Subject: PL/2024/09976 - Land off Southampton Road and Junction Road, Alderbury, Wiltshire

Following receipt of the drainage comments (dated 13th December 2024) submitted in connection with our application, we have reviewed the matters raised and would like to provide the following response to the LLFA, which we hope addressed the concerns.

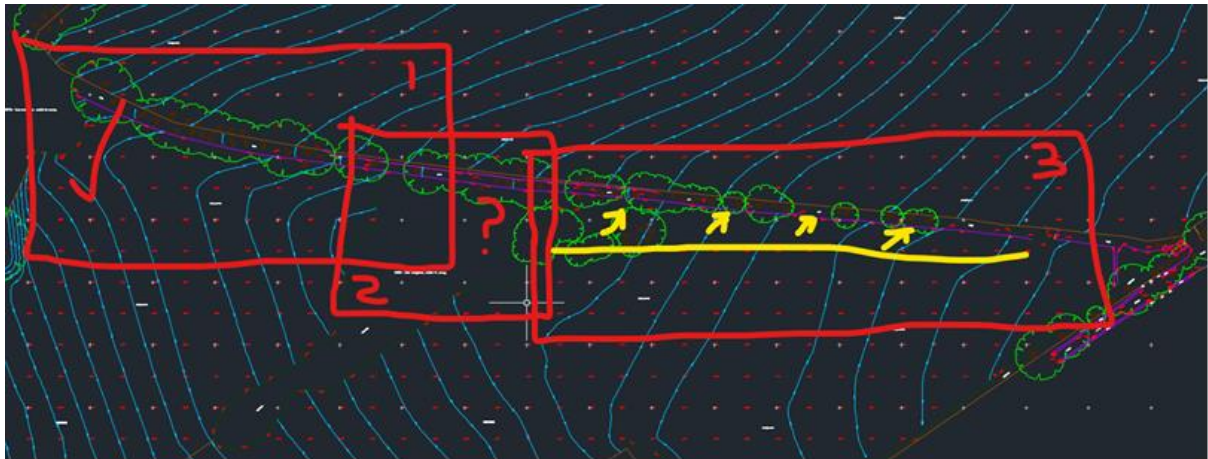
1. The applicant should undertake a capacity assessment of the drainage ditch and any downstream drainage infrastructure to demonstrate that flows from the proposed development can be accommodated without increasing flood risk elsewhere.

It does not make sense that there is a depression located just south of the ditch. This has therefore been assumed to be erroneous. Upon close review of the numbers (not the contours) the land to the north of the yellow line on the image below falls towards the ditch (topographic survey is attached). We don't have enough level information to determine what is happening in the overgrown marsh area, identified as box 2 in the image below.

All surface water eventually finds its way into the high risk flood areas to the south, adjacent to the A36, as identified in the attached flood map and on shown on the image below.

Response to recommendation 1:

Applying the 1 litre/second rate to the developed catchments (see below response to recommendation 2) we will be alleviating the flooding downstream.

The overall flow from the completed development site could be as low as 8 litres/second (Catchment 01 @ 1l/sec, Catchment 02 @ 1in100yr greenfield rate of 6 l/s, Catchment 03 @ 1l/sec). A maximum flow of 8.0 litres for the 1in100yr storm will therefore have a negligible impact on the capacity of the existing ditch along the

northern boundary. We believe that at least 8 litres/second drains into this ditch, from the 4.95 hectare site already. On this basis, there should be no requirement to undertake a capacity assessment of the ditch and downstream drainage infrastructure.
